TT395: CVO Clutch Line Orientation

CVO Clutch Line Orientation

Figure 1. Correct Tie-Wrap Location

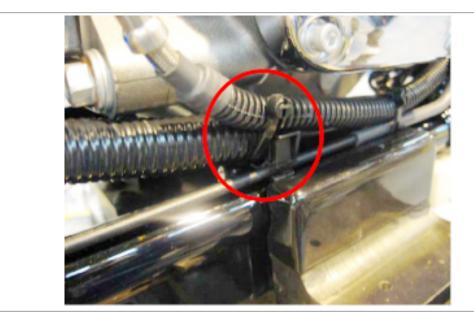
A manufacturing change was implemented in August 2008 to CVO hydraulic clutch line fittings. This change affects FLHTCUSE4 models as well as FLTRSE3 models.

The internal fitting change helps the cable maintain its proper location and prevent movement. To maintain orientation and prevent excessive movement at the hydraulic line fitting on models built prior to the change, install a tie-wrap under the transmission trap door to secure the clutch line to the existing harness loom. (see image below)

This tie-wrap will be aft of the harness and rear brake line clip on the frame tube. The tie will hold the clutch line to the harness bundle, but NOT to the brake line.

We recommend installing these tie-wraps on SE Ultra and SE Road Glide models that were built prior to August 31st. Install the tie-wraps on any of these models that are currently unsold in the dealership. Customer-owned vehicles may be updated at any time the vehicle is in the service department for maintenance.
